# Proposed Logistics Development on Land North of the A20 (Ashford Road), Hollingbourne, Kent (Ref. 23/500899/OUT)

## Review of Landscape and Visual Matters

## Technical Review of ZTV, Photography and Photomontages

## Land North of Ashford Road, Hollingbourne: Update to Technical Review of Visual Material

**Figure 2: Relationship to Designated Landscapes**

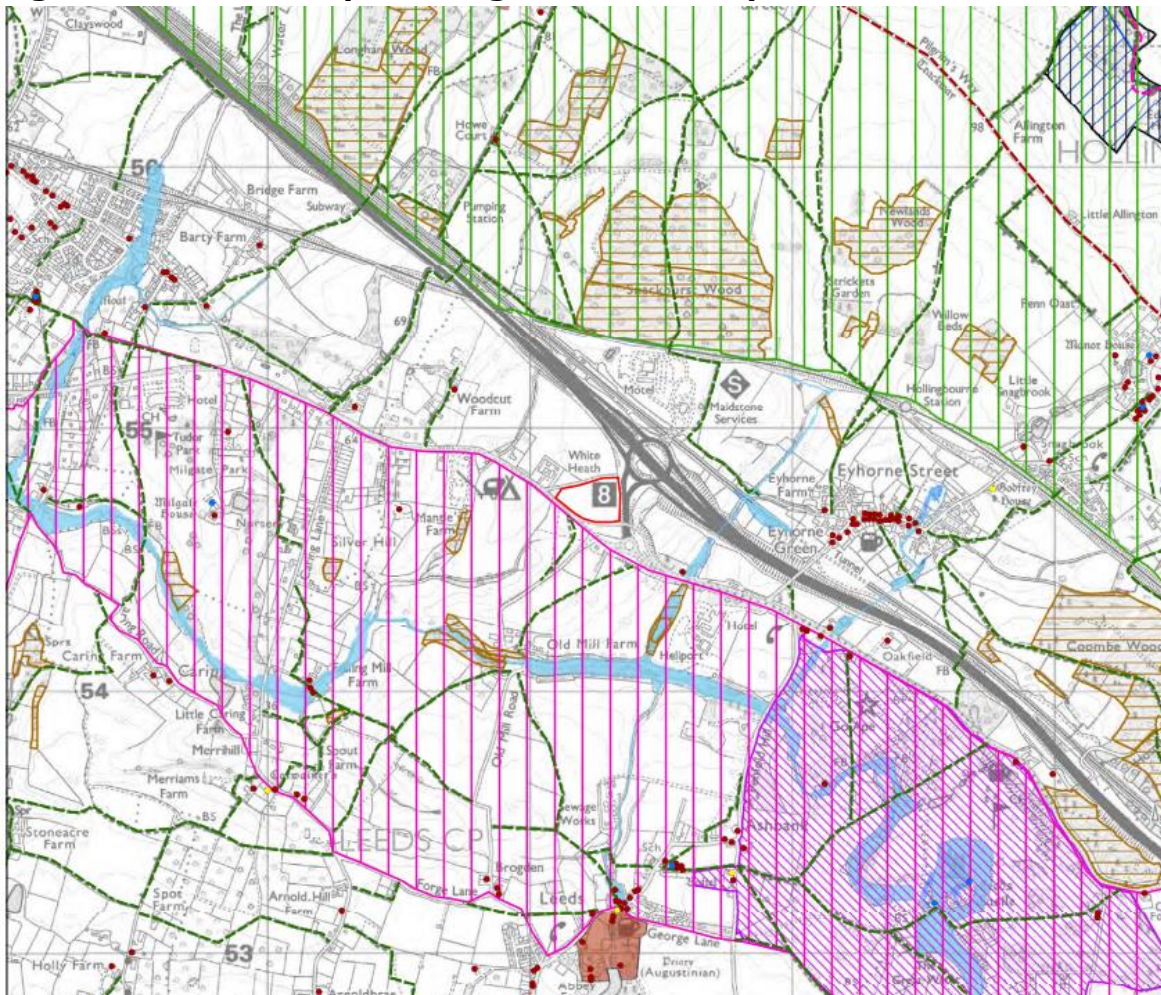
- 4.14 The site's relationship to the surrounding designated landscapes is shown in **Figure 2** below. This is extracted from the Environmental Designations Plan in the LVIA. The vertical green hatching shows the AONB, the vertical pink hatching the LLV, and the pink cross-hatching the registered park associated with Leeds Castle.
- 4.15 The ZTV and visualizations indicate that the development would be visible from parts of the AONB and LLV. However, the MSE review suggests that the visual influence of the development could be different to that indicated by the ZTV, whilst the three photomontages (which relate to viewpoints within these areas) should not be relied upon.

- 4.16 The setting of the AONB is explicitly acknowledged to be a material consideration in policy terms. Whilst this is not the case for the LLV, the latter clearly possesses a setting in terms of its inter-visibility with its surroundings, where development could potentially affect views to/from the LLV.

- 4.17 The LVIA does not explicitly assess the effects on either designated area, except to confirm that they would be indirect. Reference is made to the assessment of visual effects in Section 6, which includes an assessment of the scenic value of each view. However, it does not relate this value to the degree to which each view may contribute to an appreciation of the special qualities of the AONB or the valued characteristics of the LLV.

- 4.19 In view of the MSE comments, the reliability of these conclusions cannot necessarily be taken as read. My own observations suggest that a material effect on the setting of/views to/from the LLV cannot be ruled out. However, this is less obvious in relation to the AONB, due to the greater separation distance. The preparation of accurate versions of the visualizations would be required before this could be confirmed.
